<u>**Staff Report – December 10, 2013**</u>
1700-1702 Thames Street
Baltimore City Historic District Fells Point
<u>**Staff Presenter:**</u> **W. Edward Leon**
<u>**Plan:**</u> **Plan Review Replacement of Basement Access Doors**
<u>**Applicant/Owner:**</u> **Patrick Russell**

Existing Doors

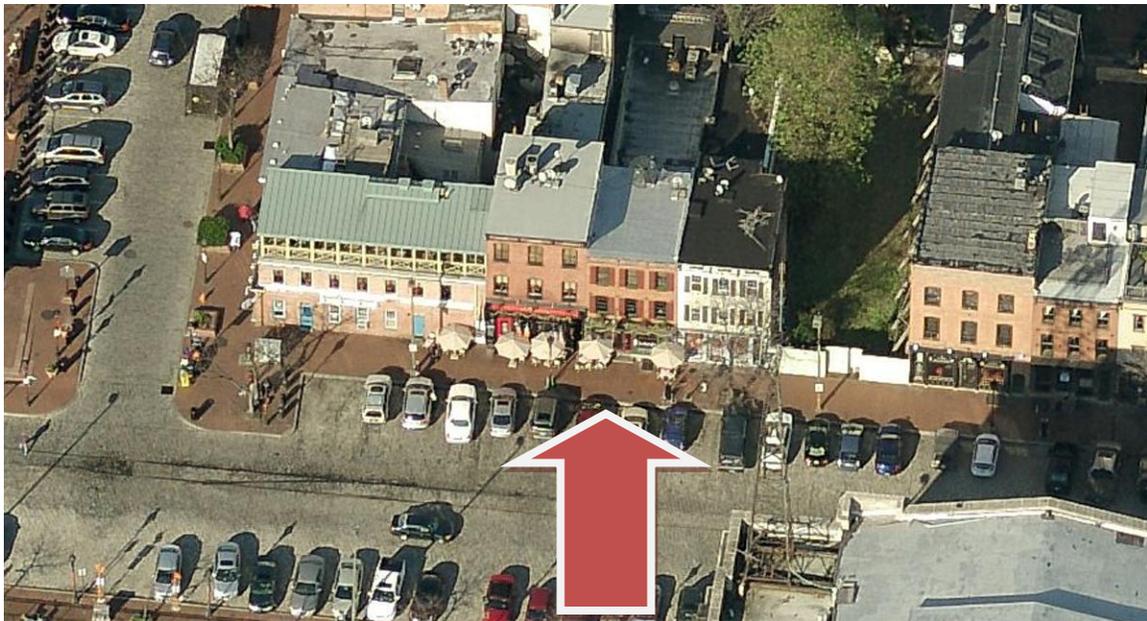
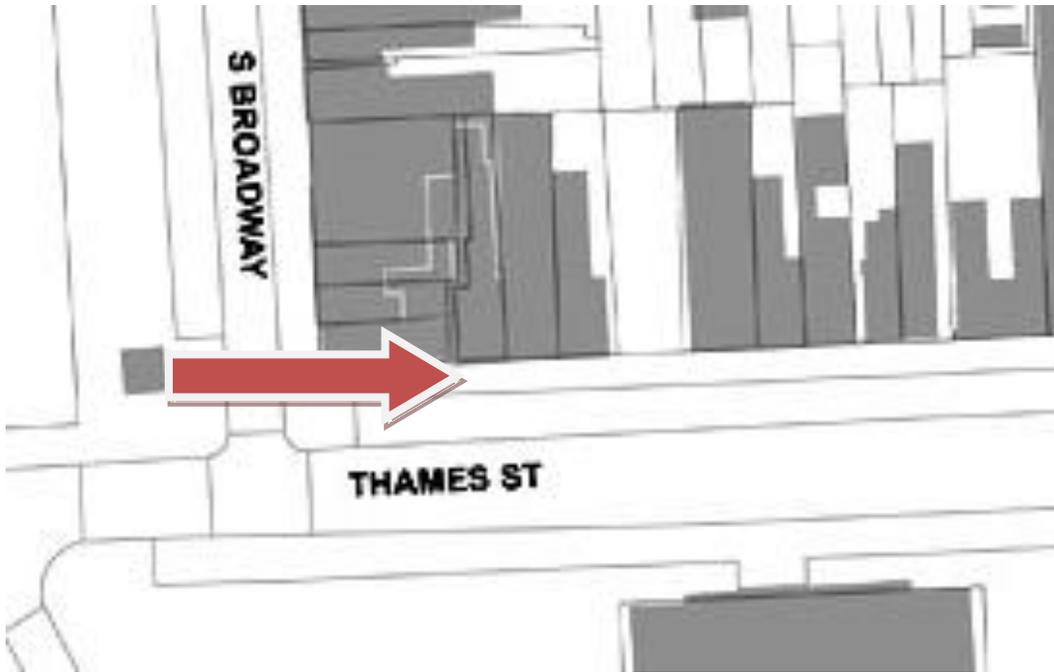
Plan
The plan is to replace the exterior metal basement doors located on the sidewalk adjacent to the main historic structure with new contemporary metal bilco doors and reset the granite frame to be flat to match sidewalk grade.

Analysis
The proposed replacement is contrary to the current Preservation Guidelines 8.1, 8.4. and 8.5. In that the existing metal basement doors, while not original, were designed to replicate the style of doors used during the period of significance.

Staff Recommendation
Dis-Approval of the plan as submitted with final design elements to be reviewed by staff as the plan does not meets Baltimore City Historic Preservation Procedures and Design Guidelines:8.1, 8.4 and 8.5.

However, staff recommends that the applicant explore resetting the granite frame, installing the bilco doors and readapting the existing metal doors on top of the new bilco doors in order to maintain the historic appearance.
